Proposal for the 03 series of amendments as Phase 3 of Regulation No. 129 (Enhanced Child Restraint Systems)

Submitted by the expert from France

The text reproduced below was prepared by the expert from France. It introduces the 03 series of amendments to Regulation No. 129 (Enhanced Child Restraint Systems (ECRS)) that were agreed upon by the experts of the Informal Working Group on Child Restraint Systems (IWG CRS). The modifications to the existing text of the UN Regulation, including ECE/TRANS/WP.29/GRSP/2016/19, ECE/TRANS/WP.29/GRSP/2016/22, ECE/TRANS/WP.29/GRSP/2016/23 and Annex V to the report of the sixtieth session of the Working Party on Passive Safety (GRSP) (see ECE/TRANS/WP.29/GRSP/60, paras. 35 and 36), are marked in bold for new or strikethrough for deleted characters. **This document supersedes ECE/TRANS/WP.29/GRSP/2017/17. It includes all proposals of modifications made by the IWG ECRS during the two last meetings (2017/03/09 and 2017/04/19).**

Figure 2
Arrangement for testing a rearward-facing device, not supported by the dashboard

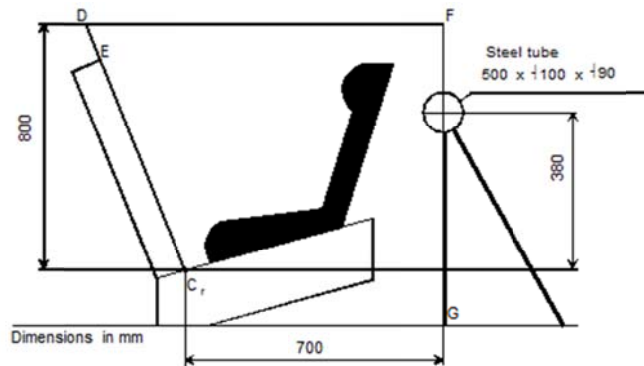
6.6.4.1.2.1. Head excursion: no part of the head of the dummy shall pass beyond the planes FD, FG and DE, as shown in figure 2 below. This shall be judged up to 300 ms or the moment that the dummy has come to a definitive standstill whatever occurs first.

Except when testing using Q6 dummy where:

- a) The value in relation to the FD plane is 840 mm

Where a test is conducted with paragraph 6.6.4.1.6.2. or paragraph 6.6.4.1.8.2. above, only the second configuration test results without 100 mm diameter bar will be considered.

Figure 4

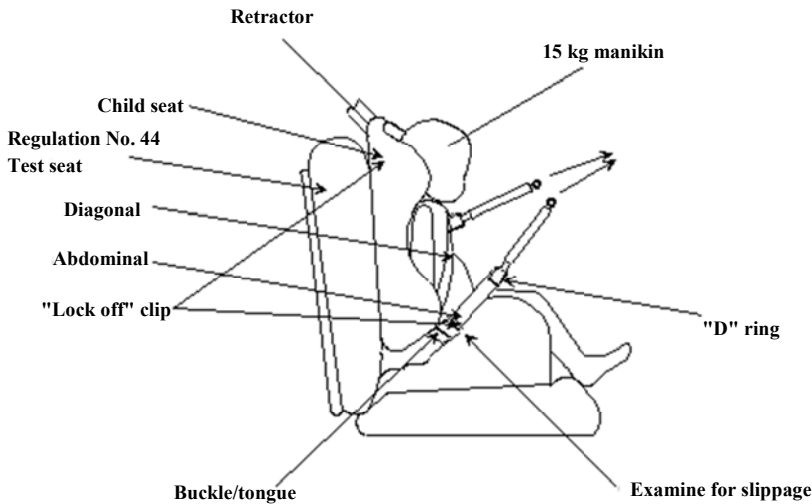
7.2.9.1. Class A devices

The child restraint and the largest manikin for which the child restraint is intended shall be set up as shown in Figure 4 below. The webbing used shall be as specified in Annex 23 to this Regulation. The lock-off shall be fully applied and a mark made on the belt where the belt enters the lock-off. The force gauges shall be attached to the belt via a D ring, and a force equal to twice (± 5 per cent) the mass of the heaviest dummy of group I shall be applied for at least one second. The lower position shall be used for lock-offs in position A and the upper position for lock-offs in position B. The force shall be applied for a further 9 times. A further mark shall be made on the belt where it enters the lock-off and the distance between the two marks shall be measured. During this test, the retractor shall be unlocked.

Figure 1
Procedure type 1

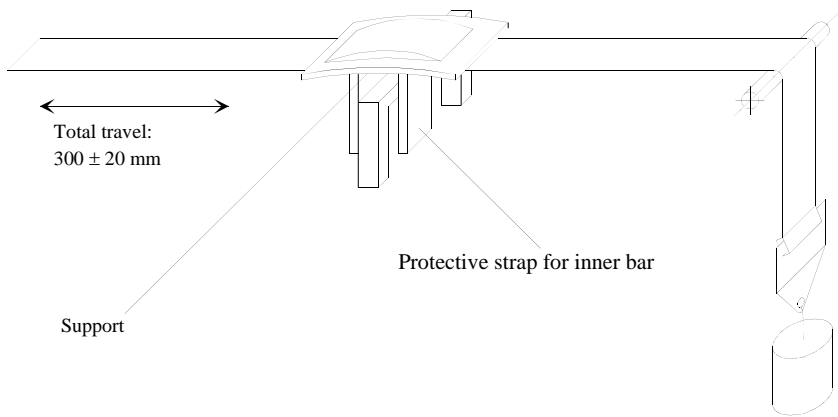
7.2.5.2.6.3.1. ~~Type 1 procedure: for cases where the strap slides through the quick adjusting device. The 10 N load shall be vertically and permanently applied on one of the straps. The other strap, set horizontally, shall be attached to a device, giving the webbing a back and forth motion. The adjusting device shall be so placed that the horizontal strap of the webbing remains under tension (see Annex 5, figure 1).~~ **Type 1 procedure: for cases where the strap slides through the quick adjusting device. Apply a load of 10 N, if necessary the load may be increased by 10 N steps so as to permit correct sliding, but limited to a maximum of 60 N. This load shall be vertically and permanently applied on the straps. The part of the strap set horizontally shall pass through the quick adjuster it is fitted to and shall be attached to a device, giving the webbing a back and forth motion. The quick adjusting device shall be so placed that the horizontal strap of the webbing remains under tension (see Annex 5, Figure 1). Activate the quick adjuster while pulling the straps in the direction to slacken the harness and deactivate it while pulling the straps in the direction to tighten the harness.**

Figure 2
Procedure type 2
Following two examples of test set up

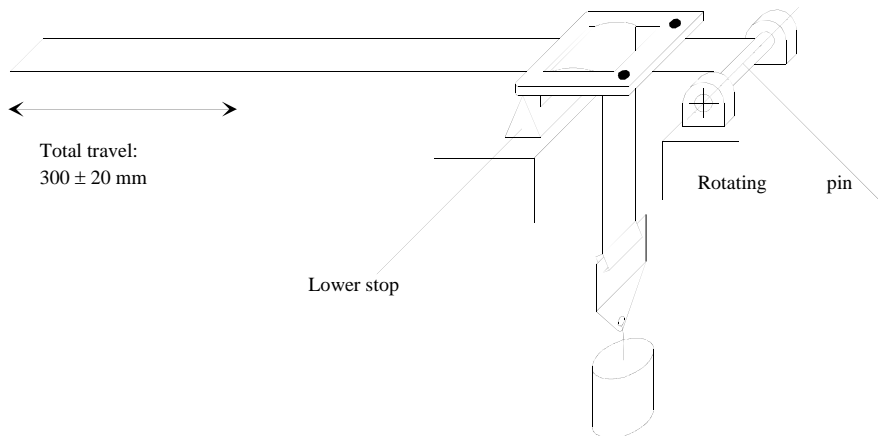
7.2.5.2.6.3.2. **Type 2 procedure: for cases where the strap changes direction in passing through a rigid part. During this test, the webbing shall pass through the rigid part it is intended for and the test set up shall reproduce the angles as in the real installation (in three dimensions), see Annex 5, Figure 2 for examples. The 10 N load shall be permanently applied. For cases where the strap changes direction more than once in passing through a rigid part, the load of 10 N may be increased by 10 N steps so as to permit correct sliding and achieve the prescribed 300 mm of strap movement through that rigid part.**
